Access Compliance Report

Public Rights-of-Way

(Pedestrian Signals)

Intersection ID: N/A	Main Street:	Cross Street: N/A	Location: N/A
ADA ID: 46FF9C48874D	Signal Type: Two Push Buttons-APS	Overall Compliance: No	Severity Score: BTN 1:N/A BTN 2: N/A No BTN: N/A
Codes/Mitigation Info/Possible Solution		Field Measurements/Component Compliance

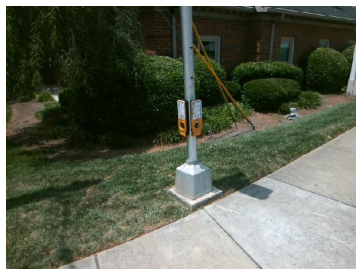
Possible Solutions: Replace Signal Push Button With APS Button on New Post. Remove & Relocate Sign.

PROW/ADA: TMUTCD 4e.08, R404.2, R406.2,
